FINAL DRAINAGE REPORT

WOODMEN HILLS METROPOLITAN DISTRICT

Engineering Review

West Water Tank

WOODMEN HILLS METROPOLITAN DISTRICT
 WEST CONCRETE WATER STORAGE TANK
 SITE DEVELOPMENT PLAN
 OVERALL DRAINAGE PLAN

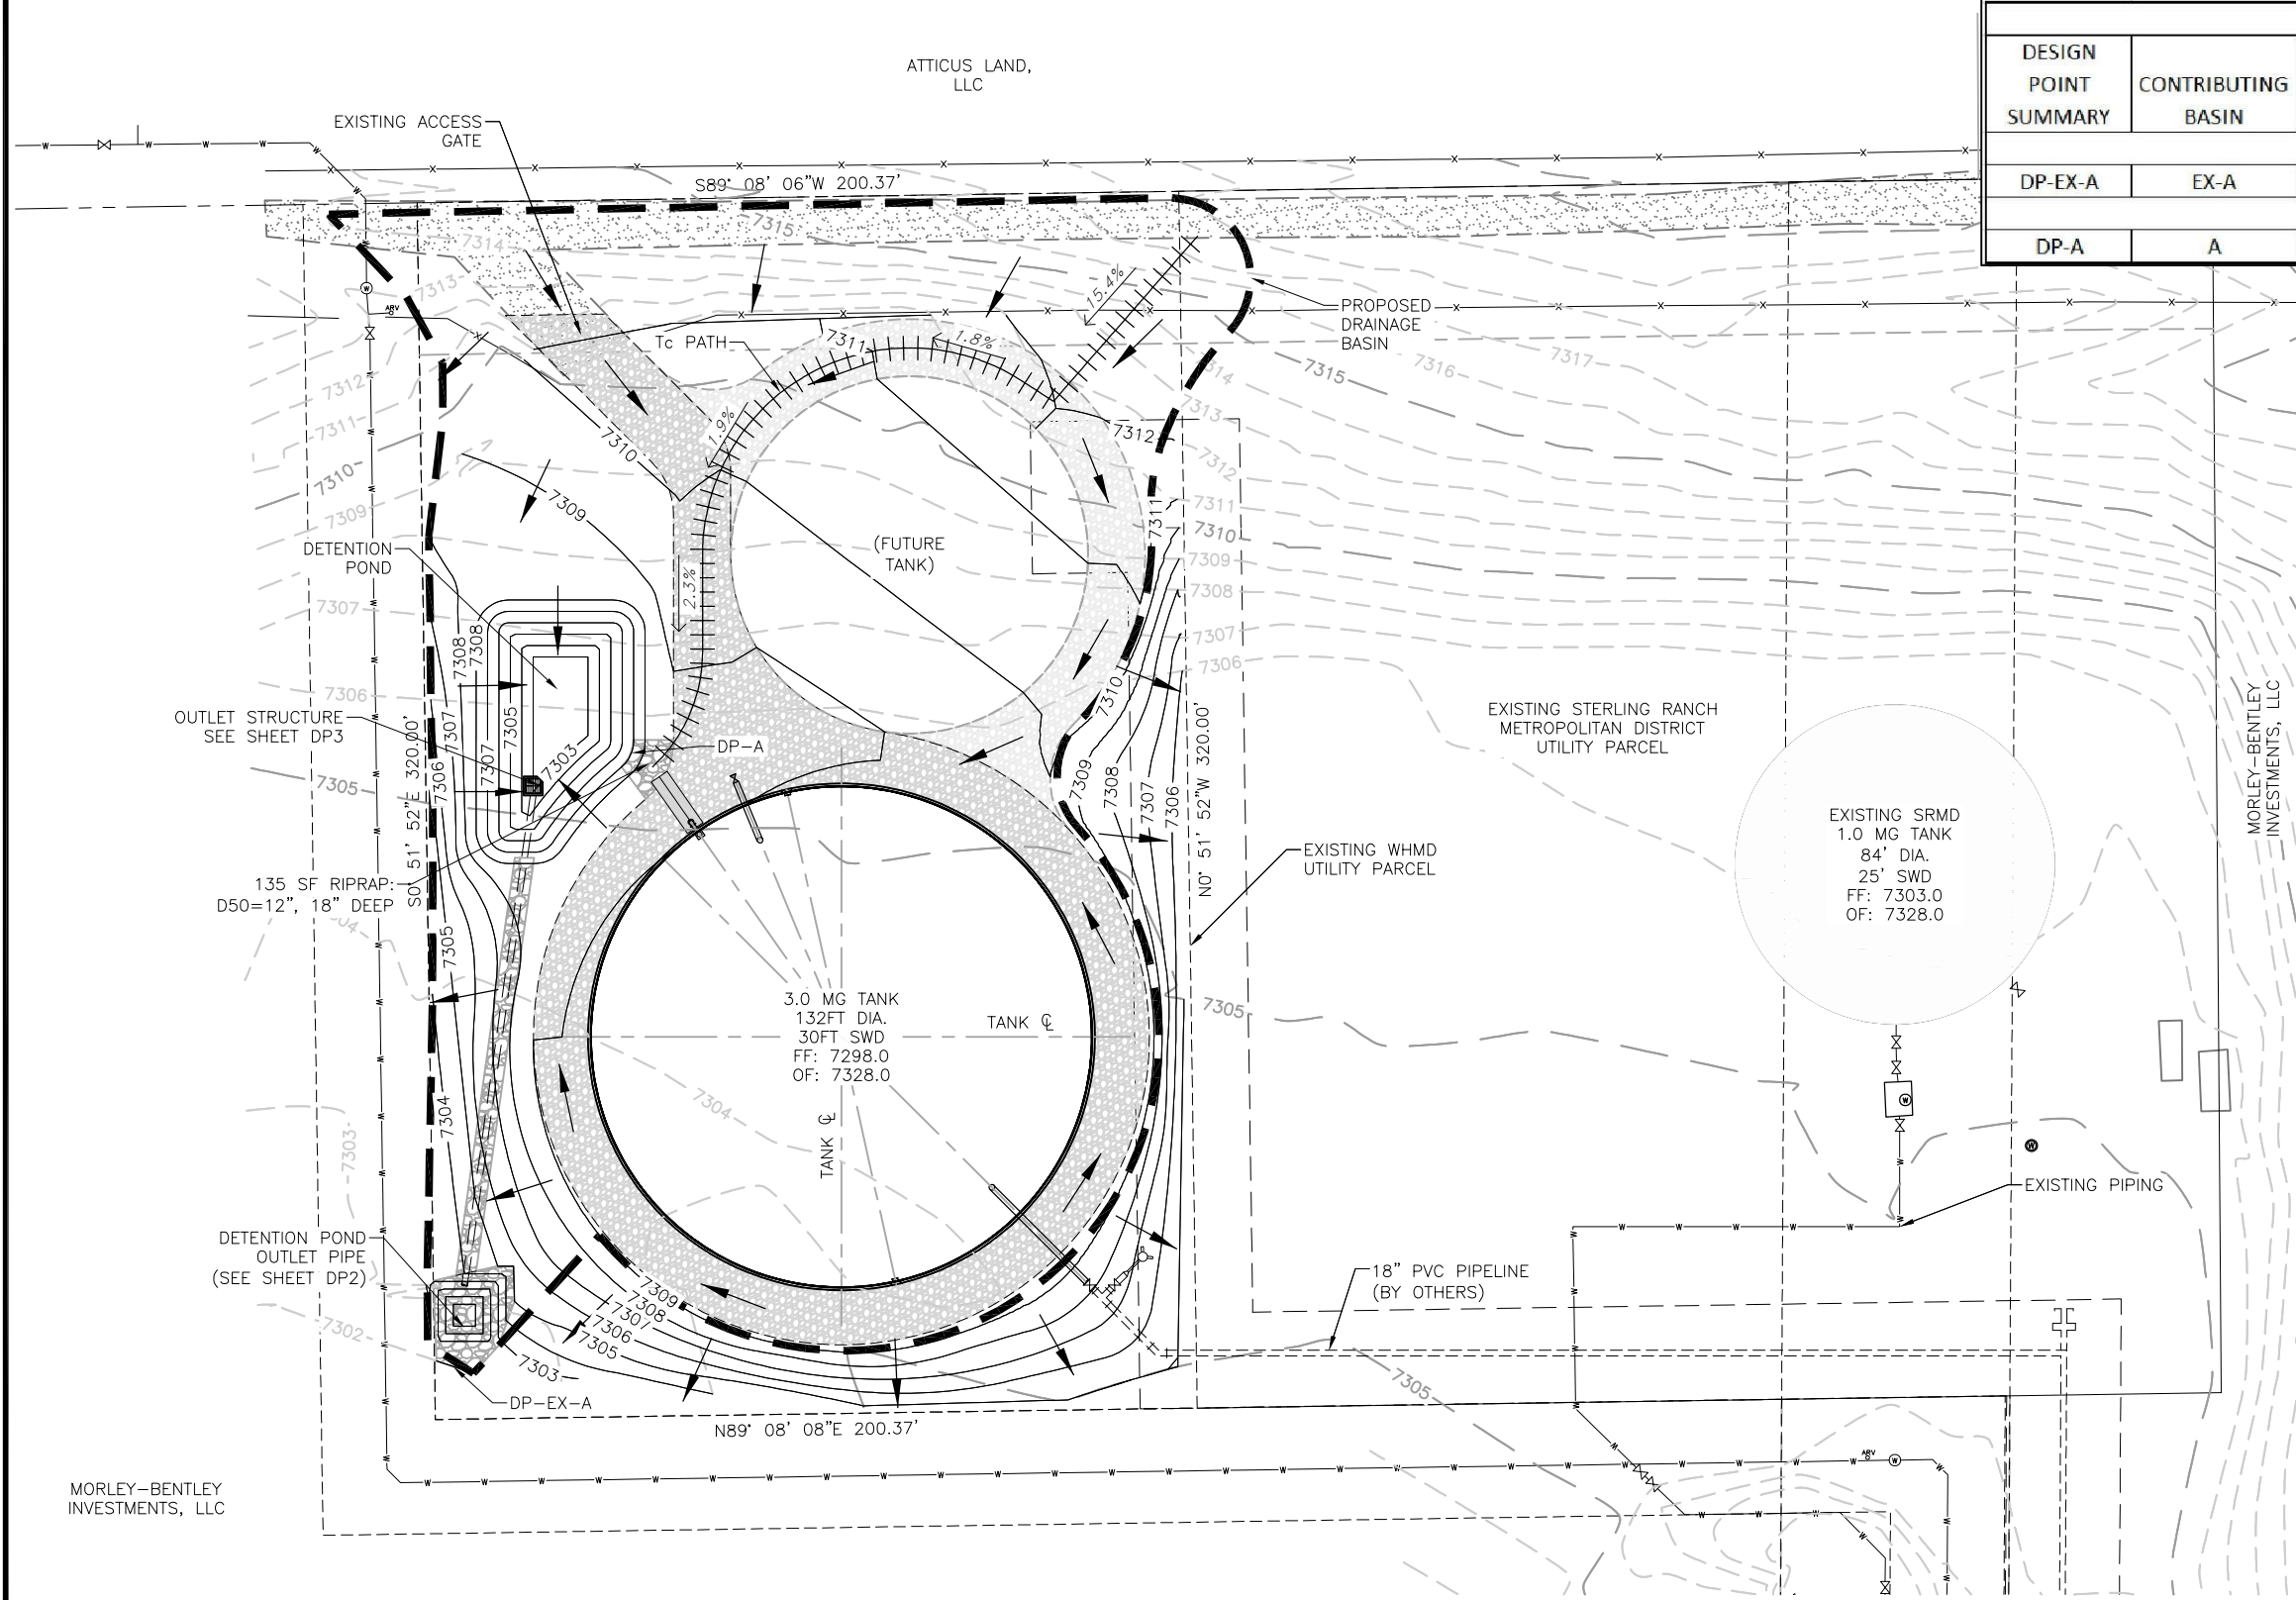
Provide a separate existing conditions Plan/Map. Show all surrounding properties with ownership.

WOODMEN HILLS METROPOLITAN DISTRICT
 WEST CONCRETE WATER STORAGE TANK
 SITE DEVELOPMENT PLAN
 DETENTION POND OUTLET PLAN & PROFILE

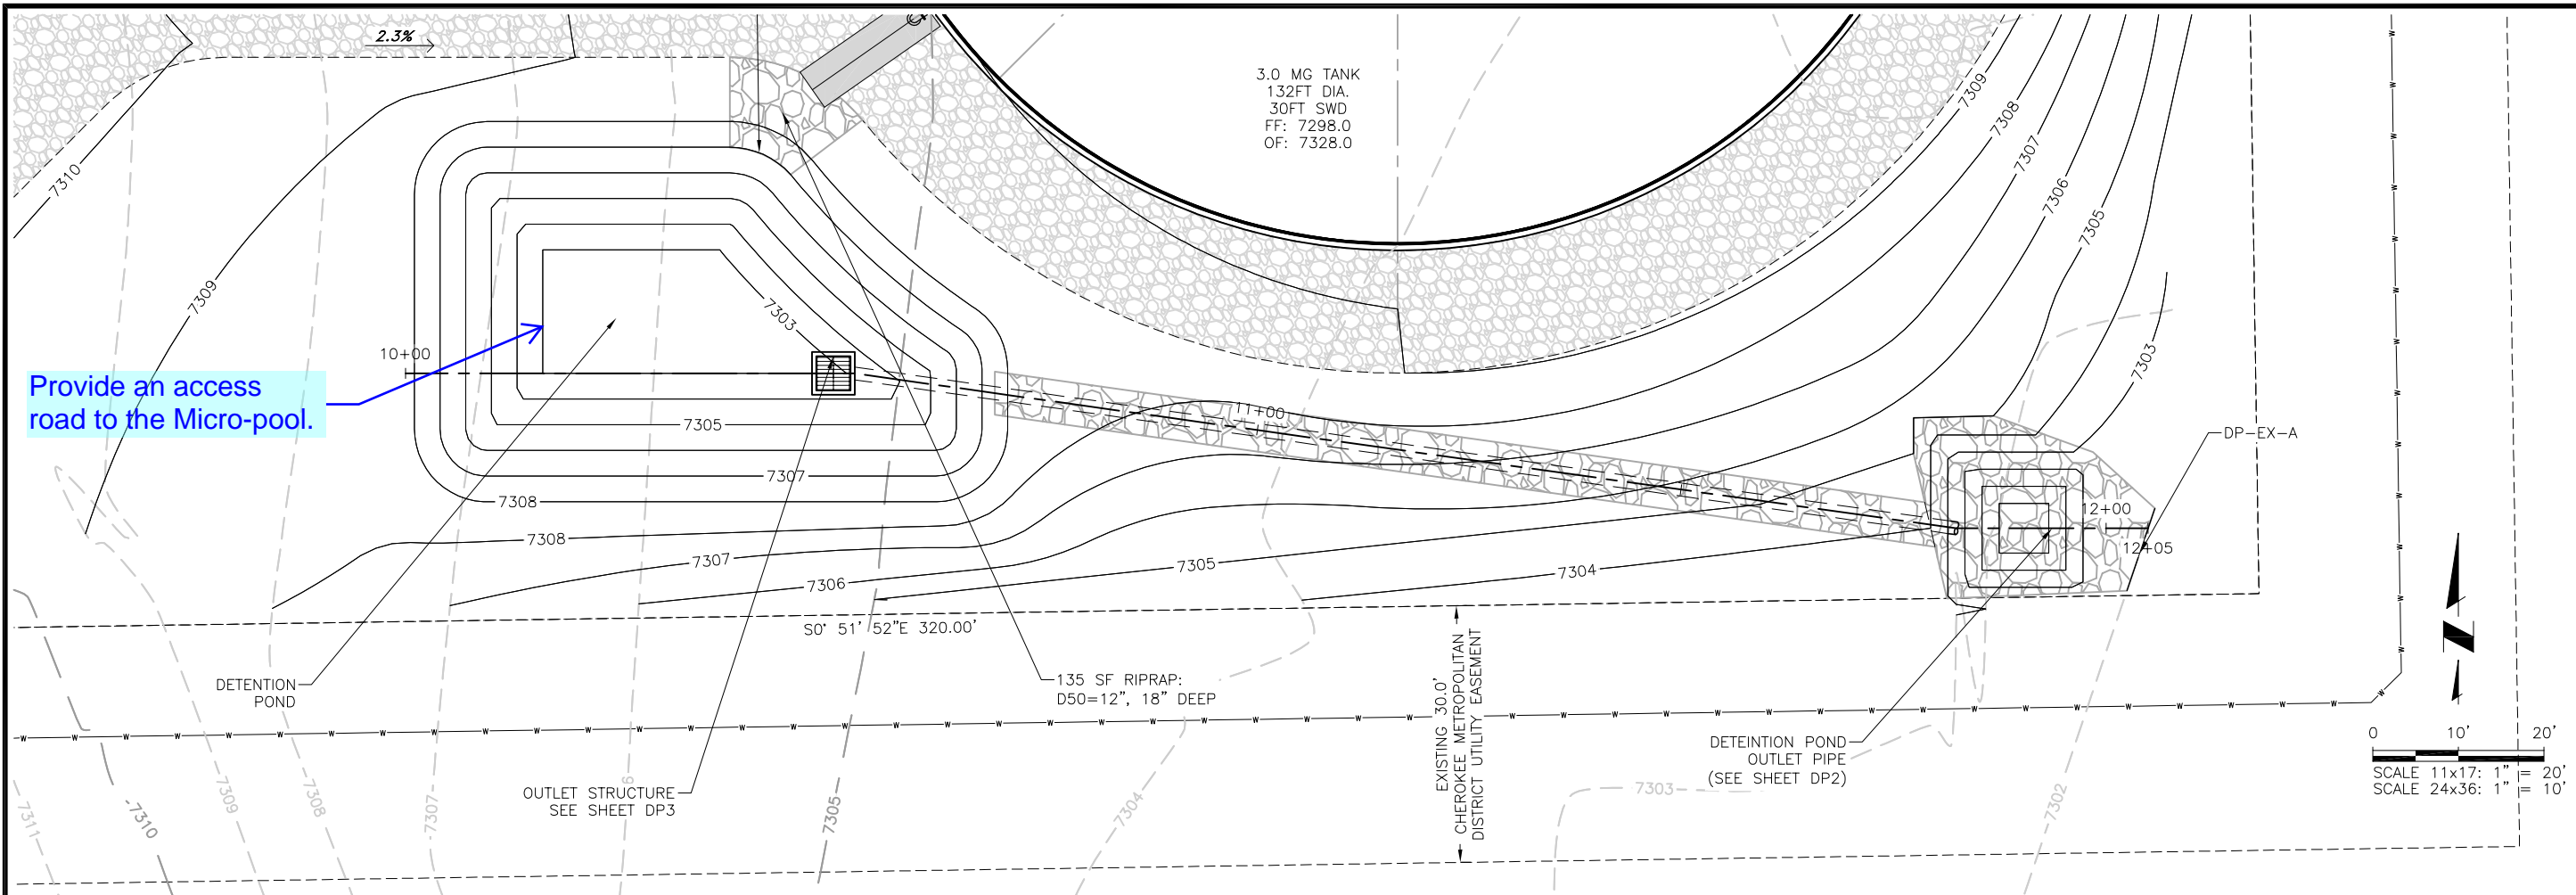
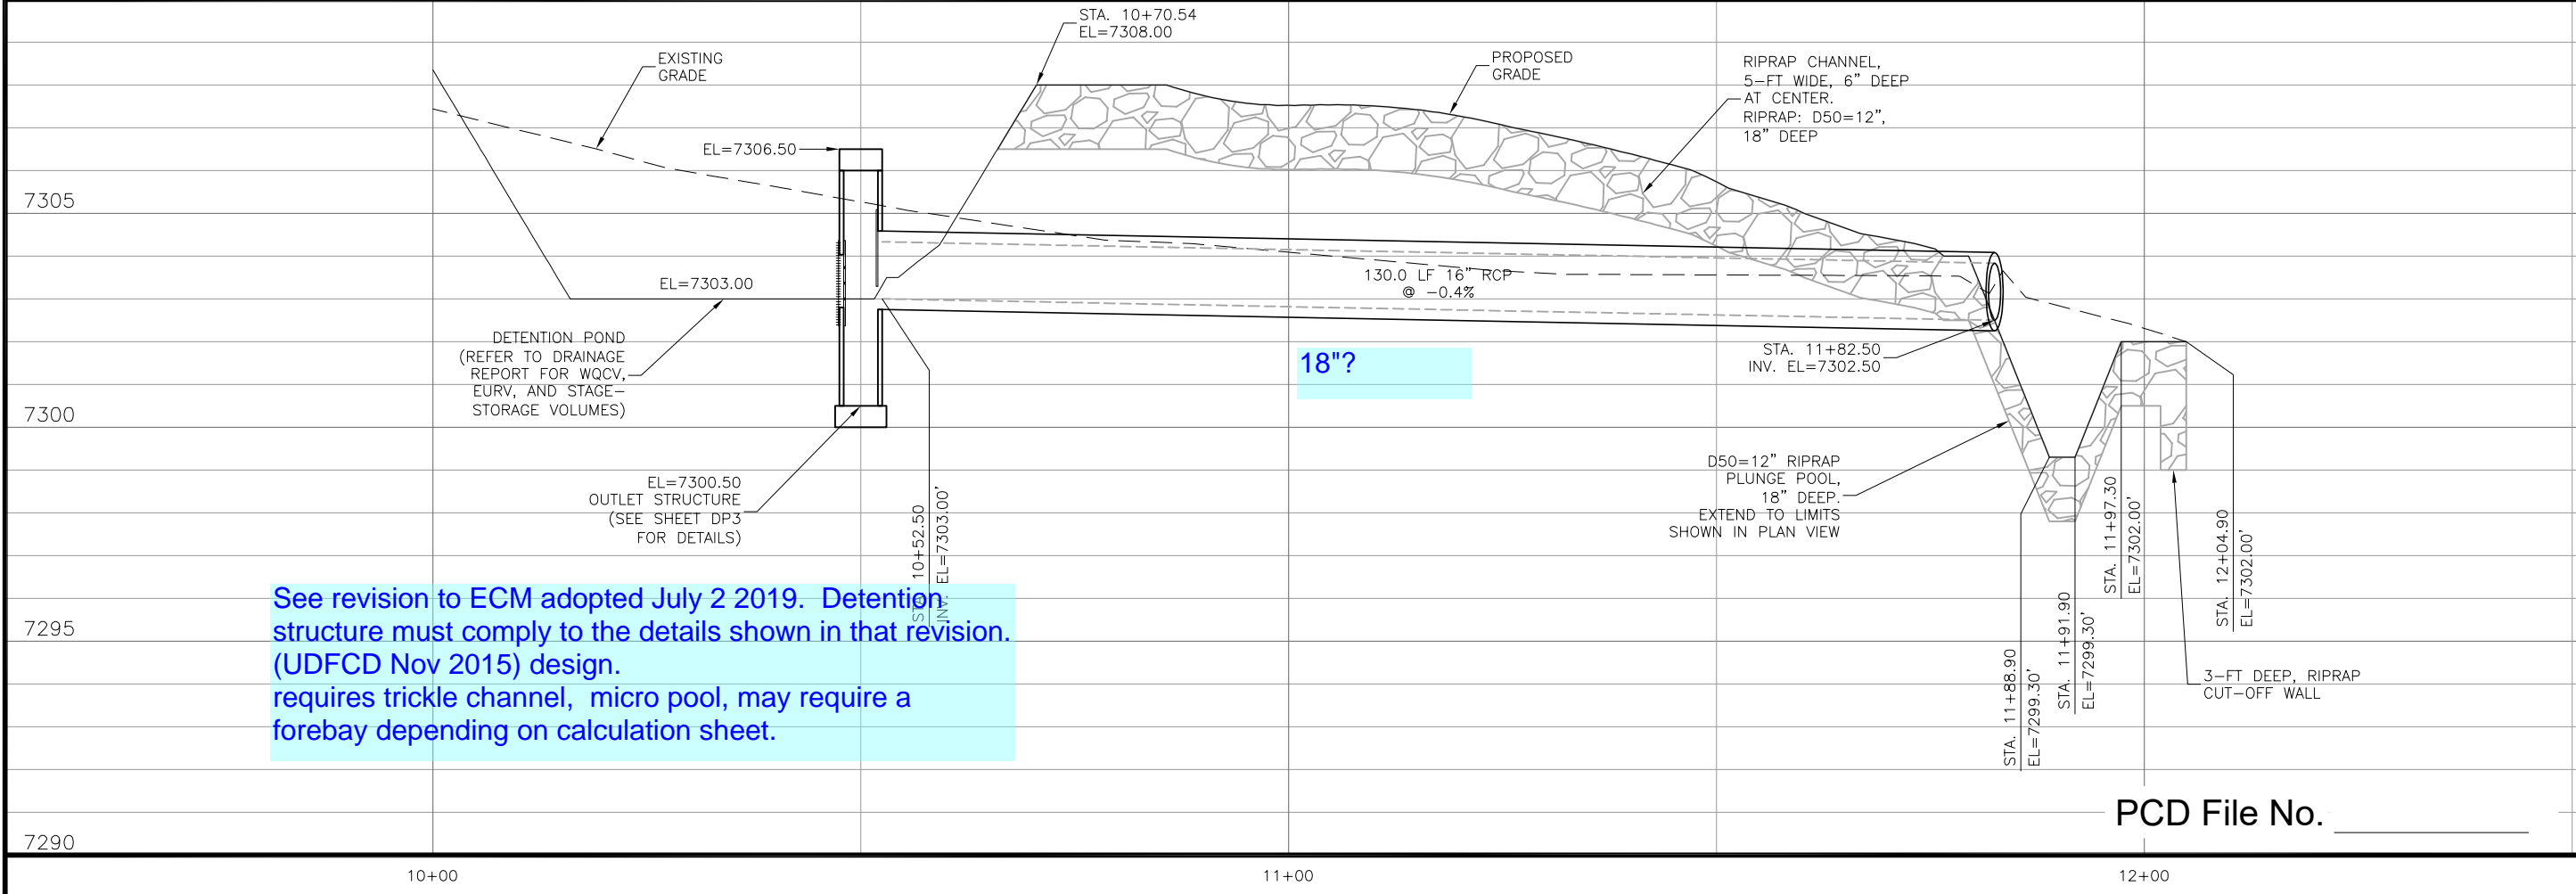
Provide an access road to the Micro-pool.

18"?

See revision to ECM adopted July 2 2019. Detention structure must comply to the details shown in that revision. (UDFCD Nov 2015) design. requires trickle channel, micro pool, may require a forebay depending on calculation sheet.
